THE GLEN AT WIDEFIELD FILING NO. 9

RESIDENTIAL SUBDIVISION CONSTRUCTION DRAWINGS

Kiowa Project No. 17038
September 25, 2018
Revised April 17, 2019

**GLEN AT WIDEFIELD FILING NO. 9
OVERALL SIGNAGE AND STRIPING PLAN**

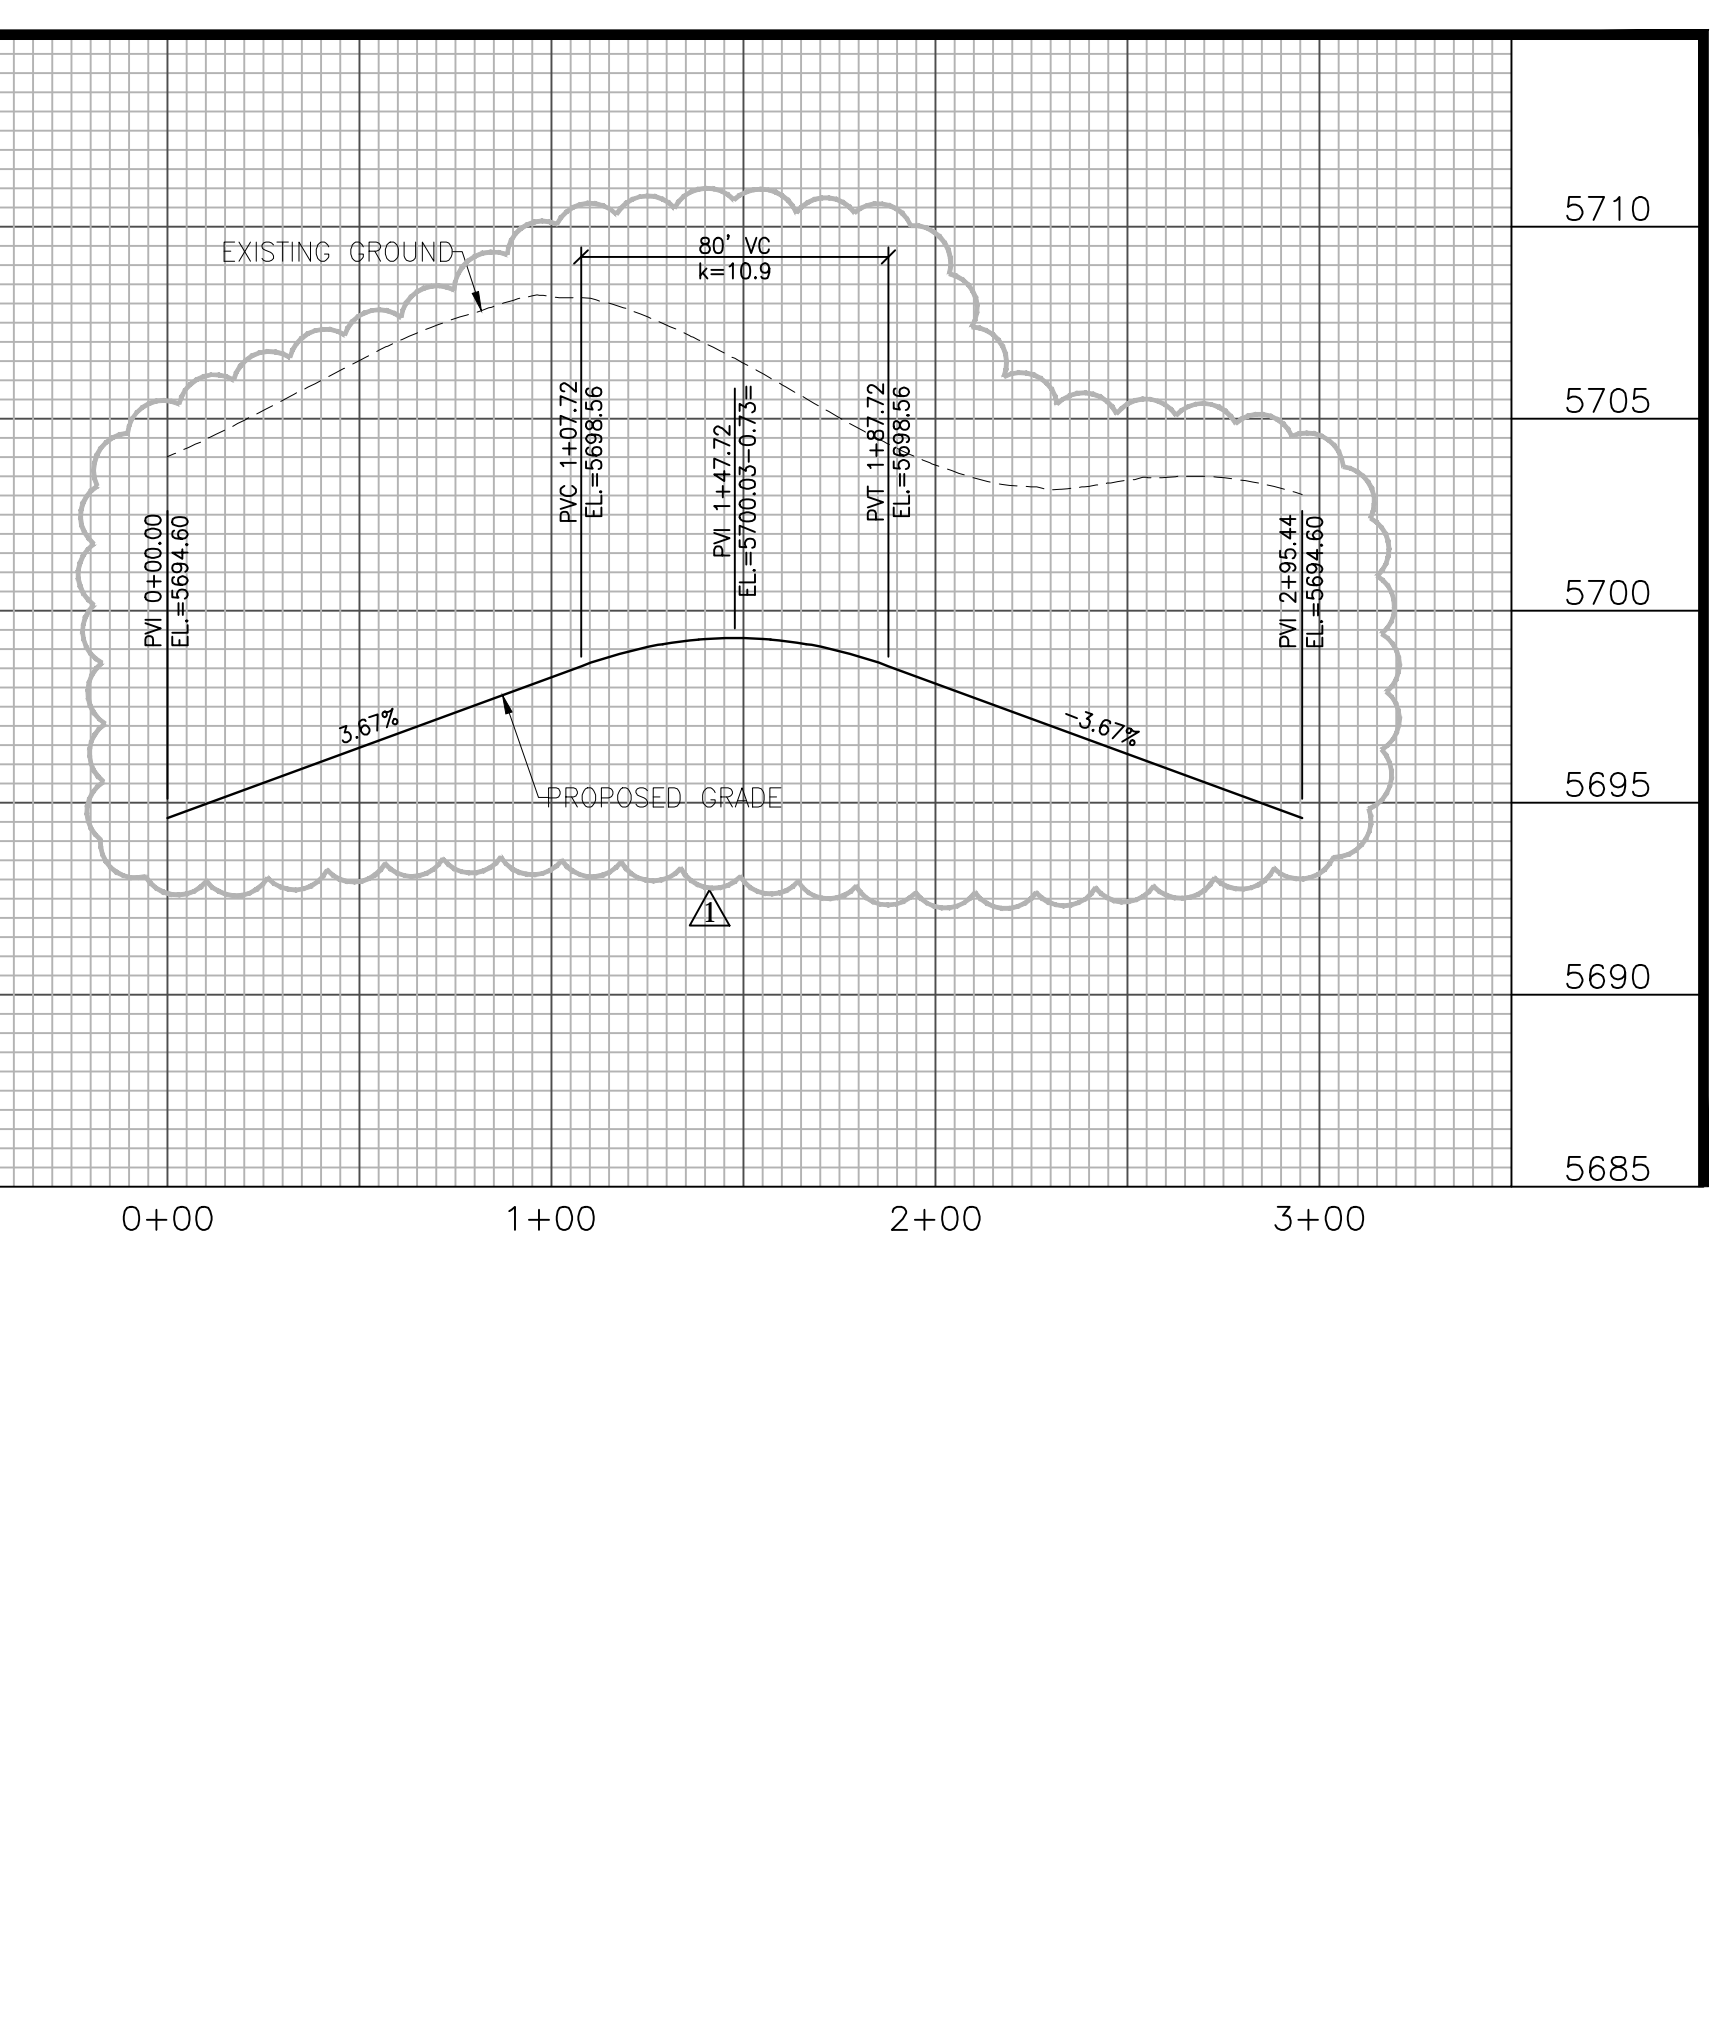
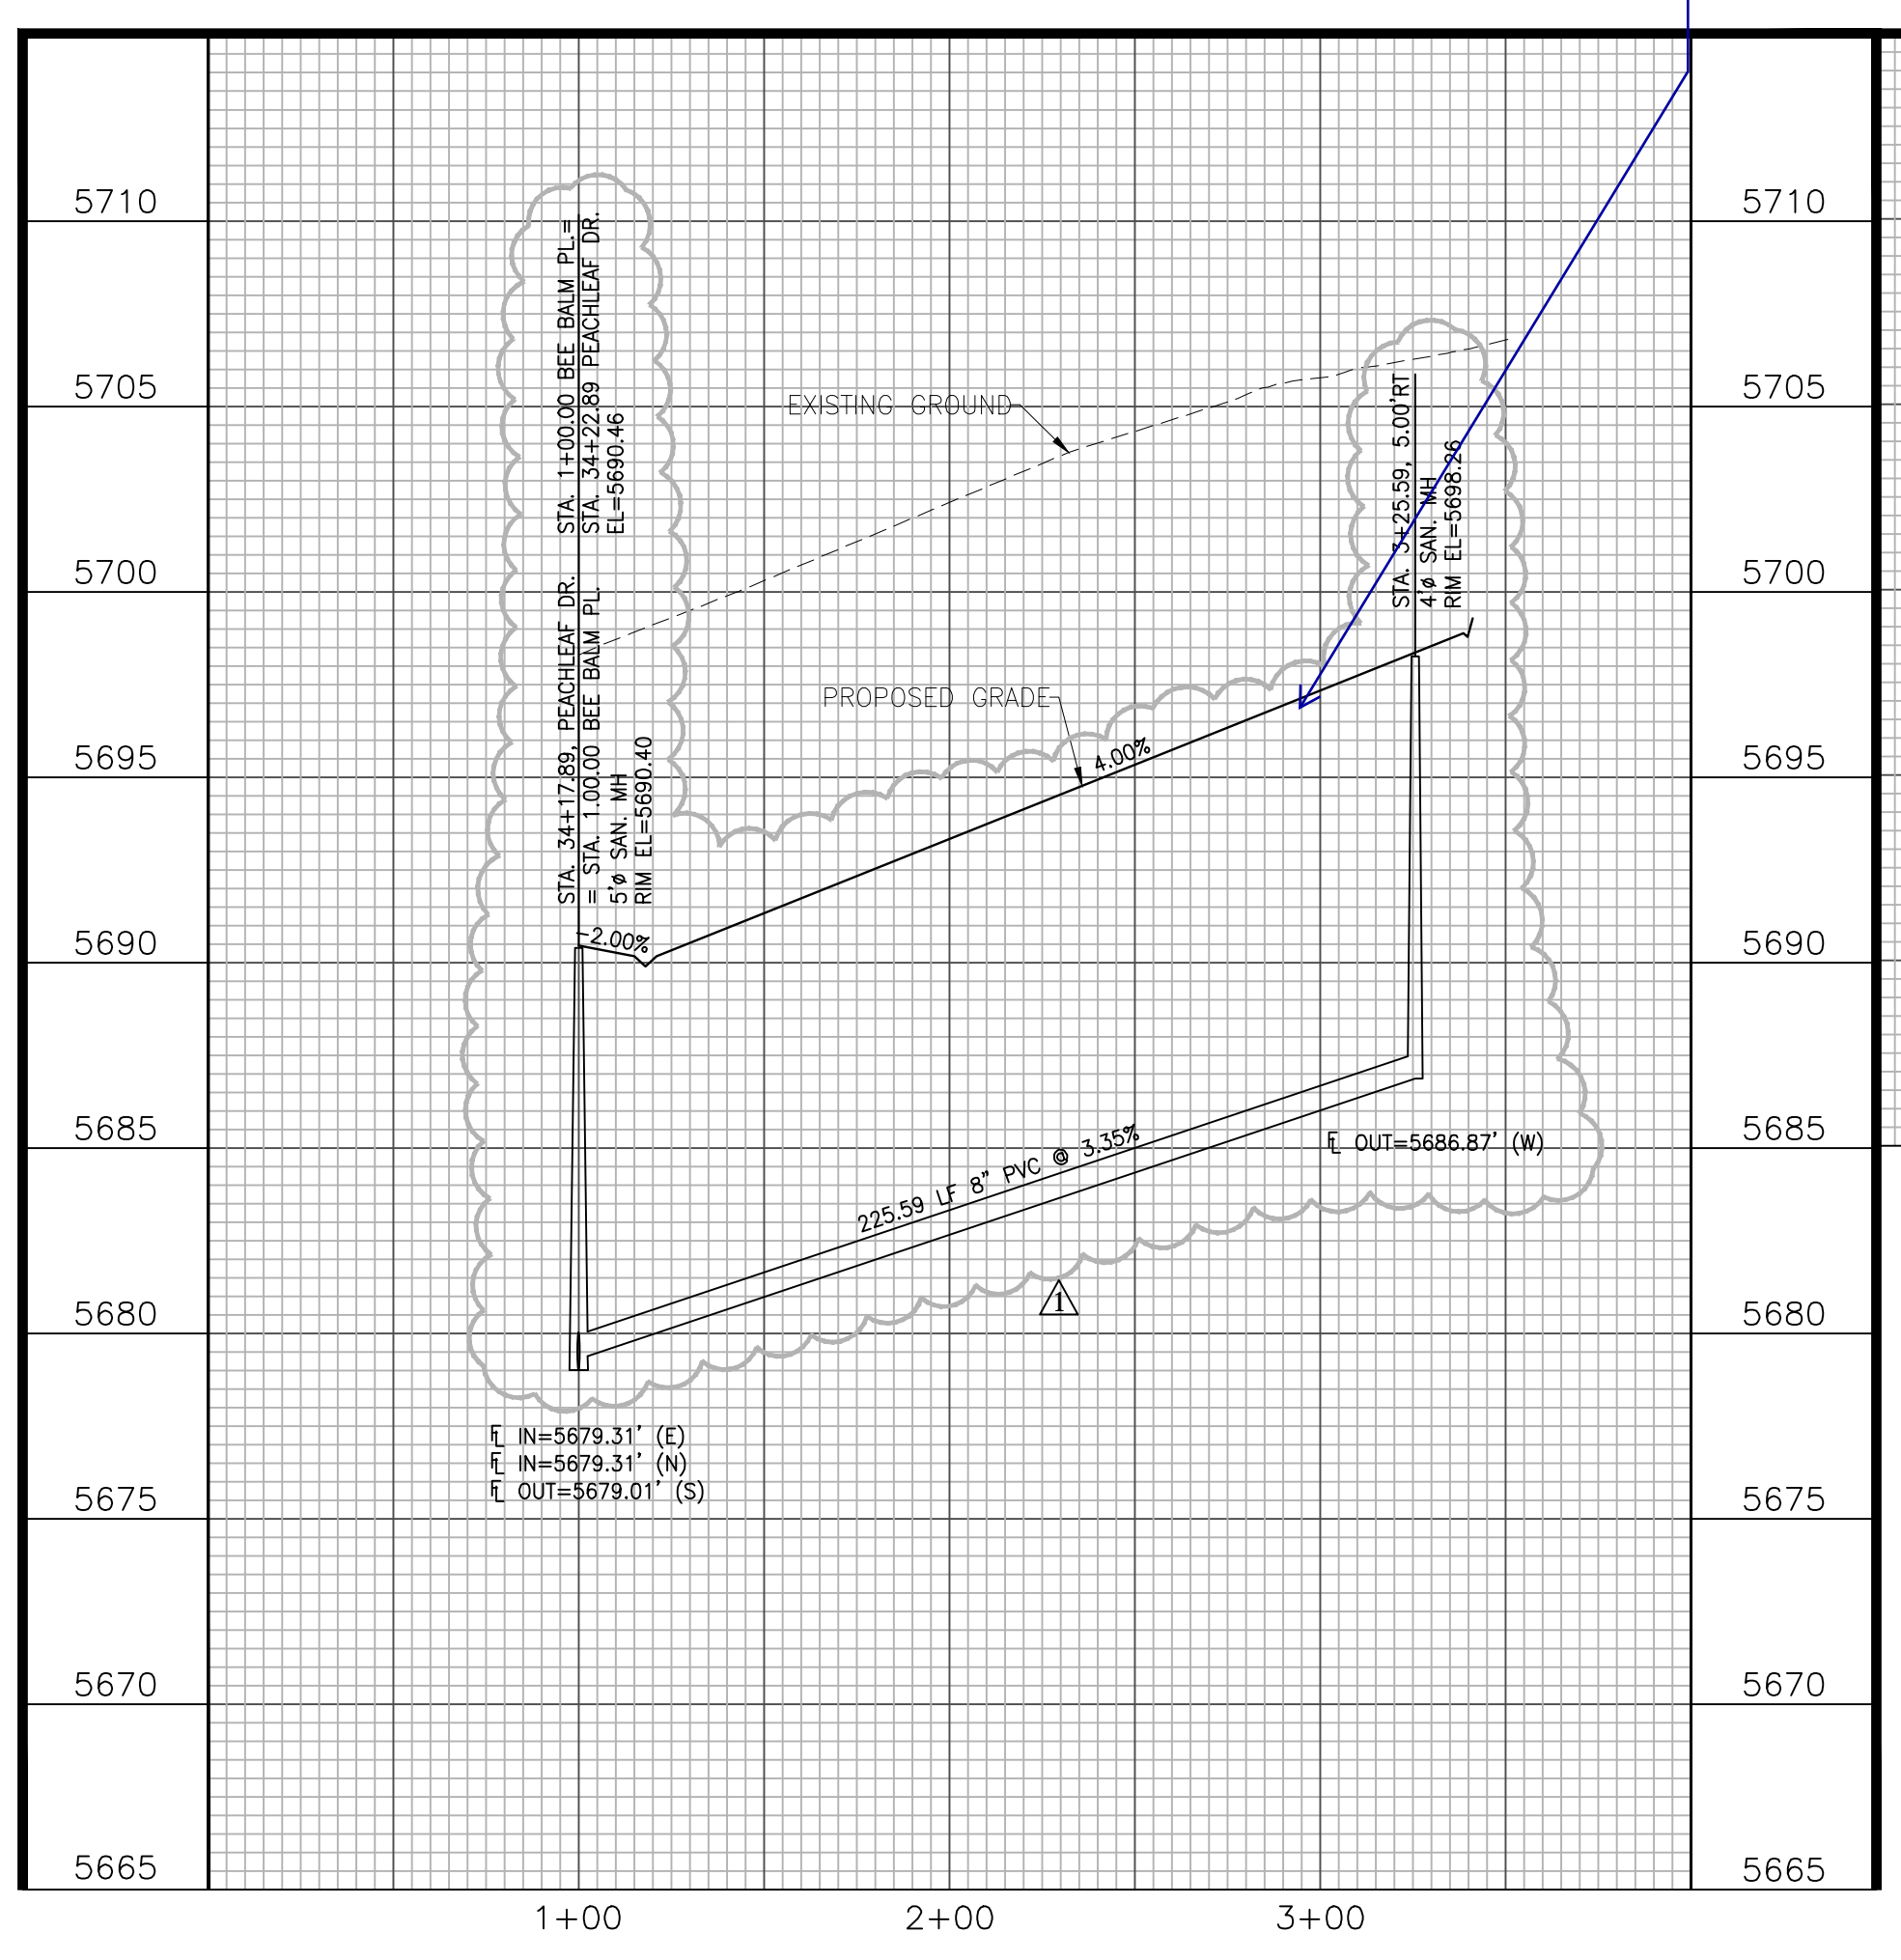
Revise profile. Cross slope of the pedestrian access path must meet ADA criteria of 2% max.

Revise centerline profile grade within the cul-de-sac bulb to 3.0% max. See ECM Section 2.3.8 Figure 2-31.

SIGN DETAILS
SCALE: 1/4" = 1'-0"

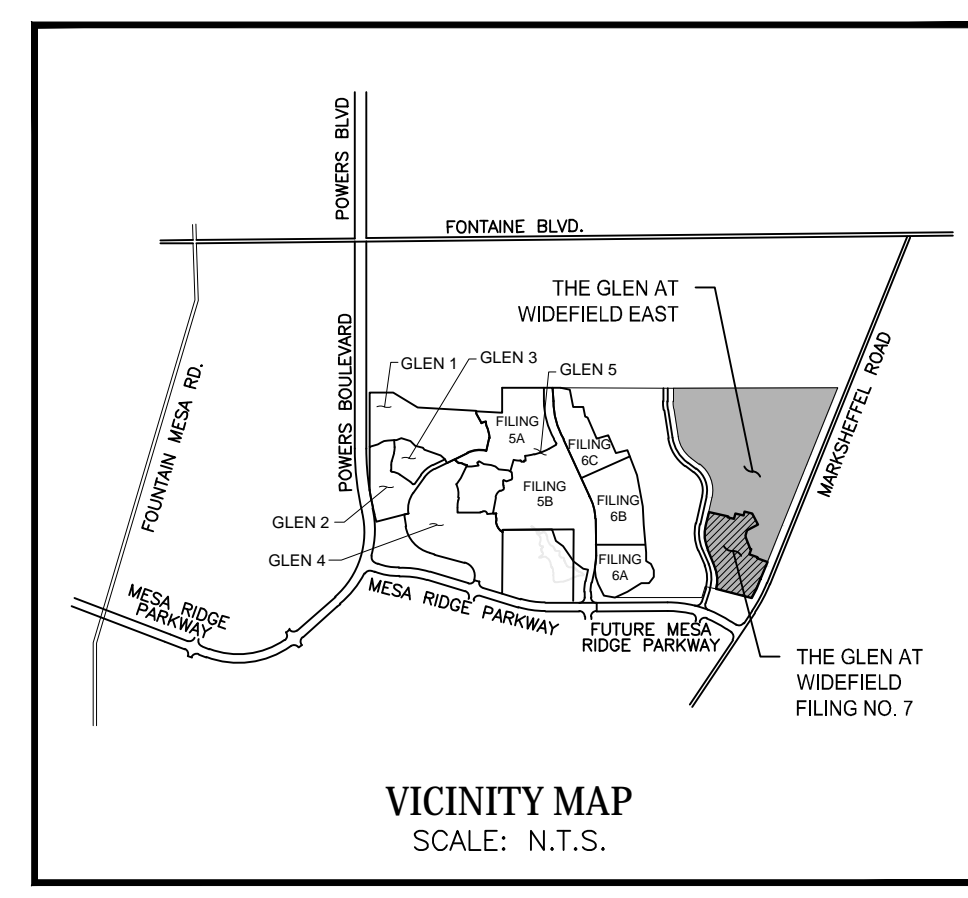
See detail this sheet for additional speed limit signage required on Spring Glen north of Mesa Ridge Parkway.

**GLEN AT WIDEFIELD FILING NO. 9
STORM SEWER PLAN (PEACHLEAF DRIVE)
PLAN AND PROFILE
EL PASO COUNTY, COLORADO**

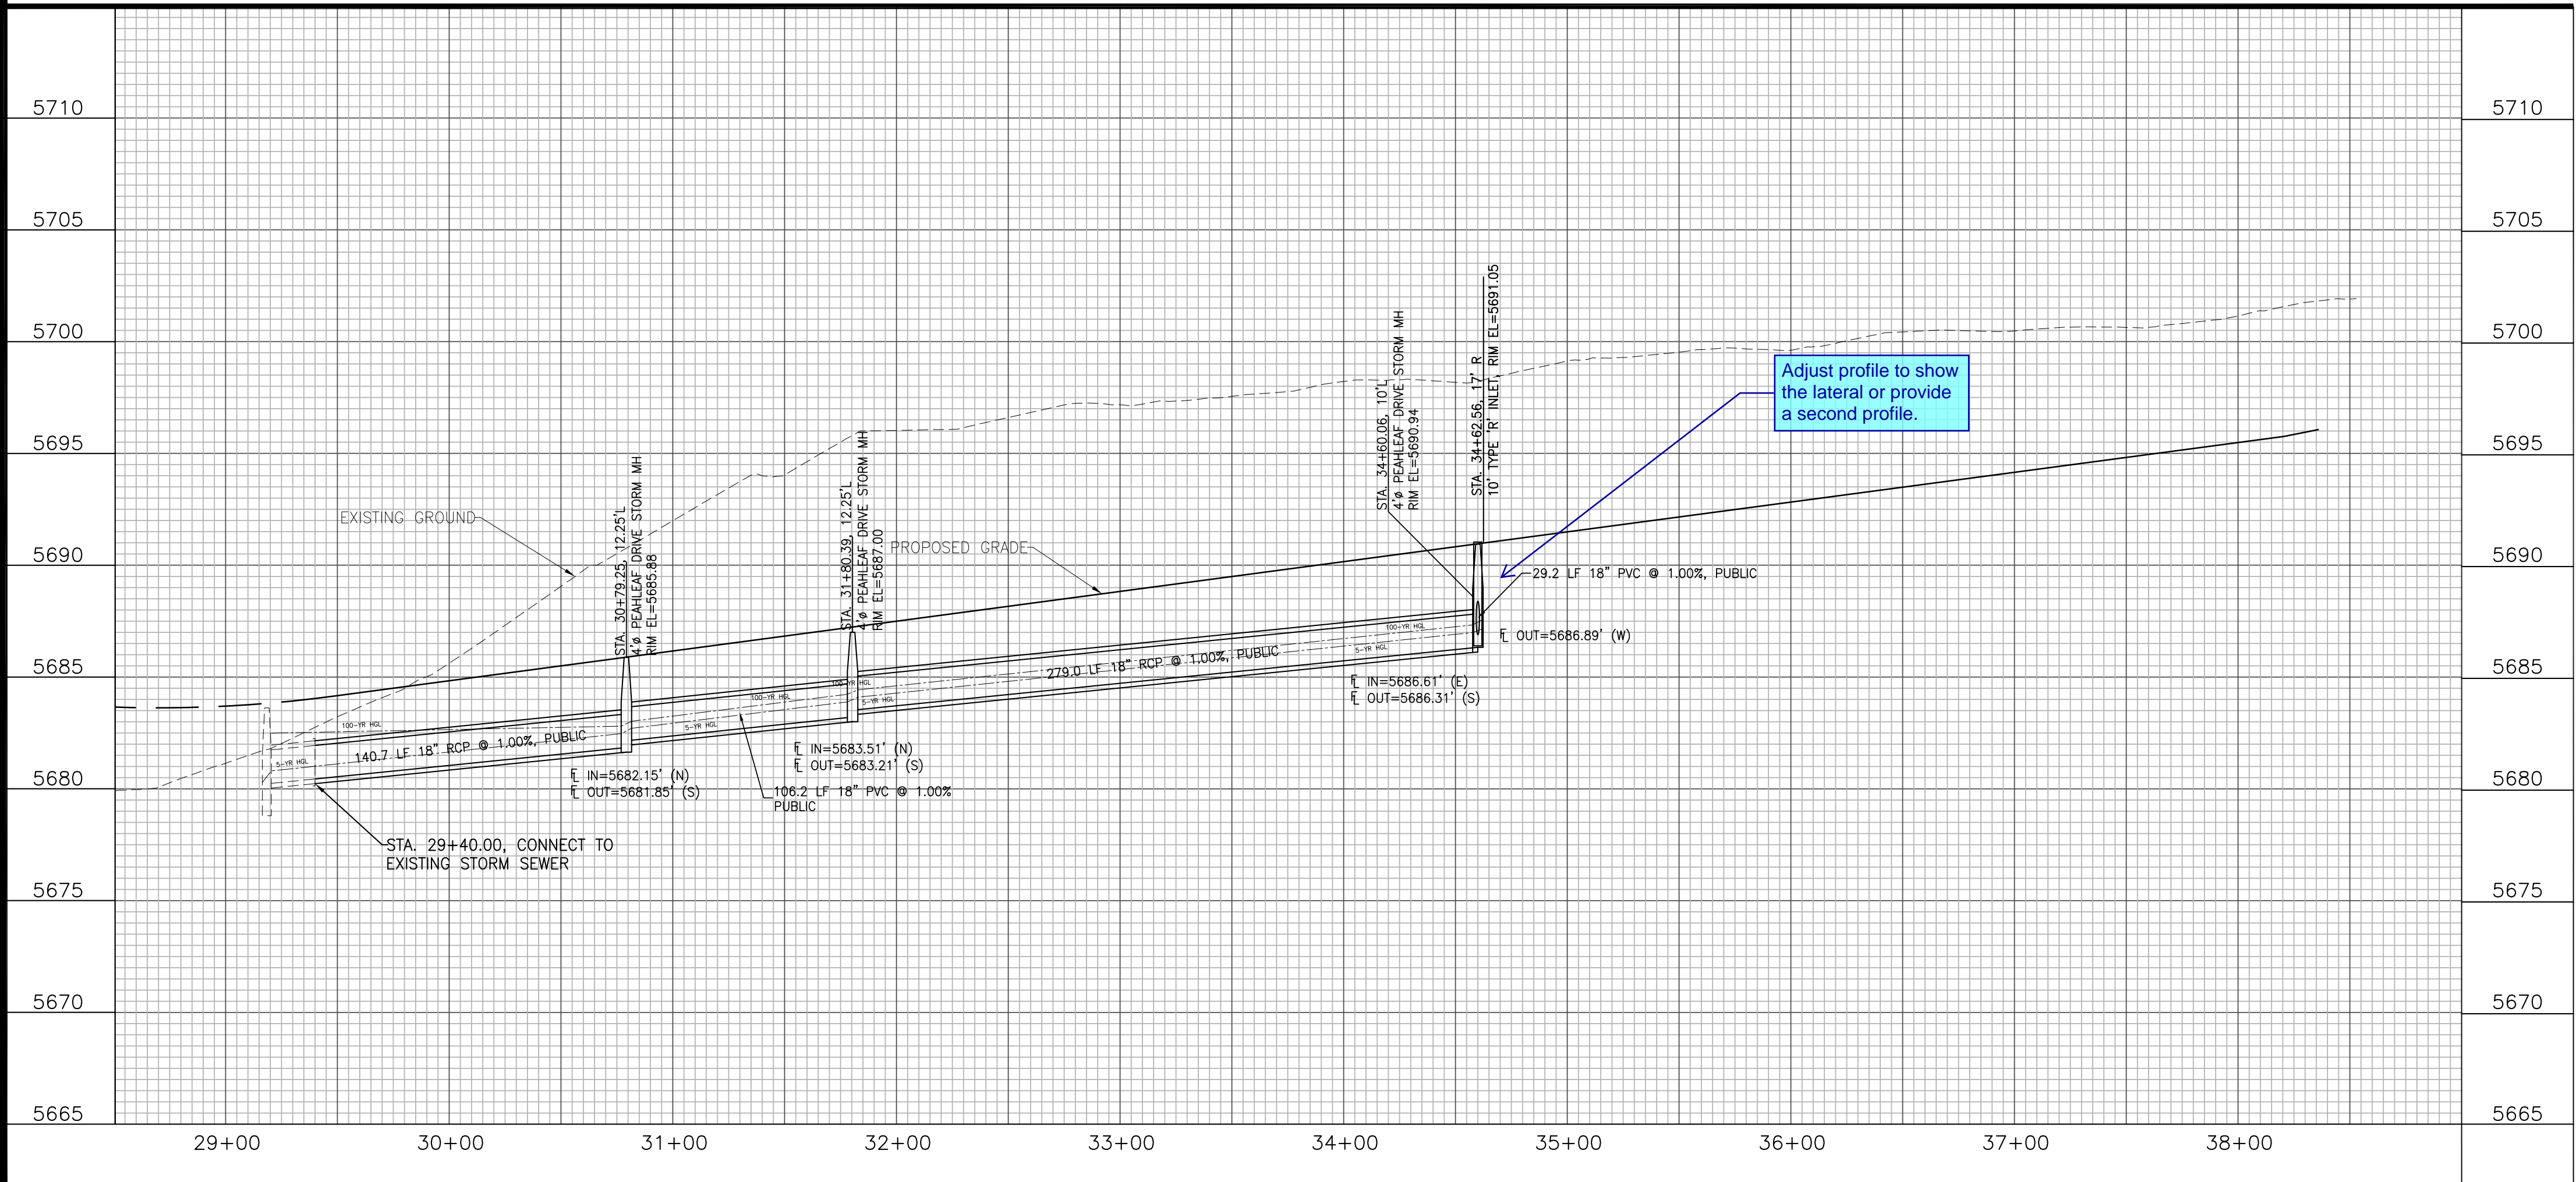
Adjust profile to show the lateral or provide a second profile.
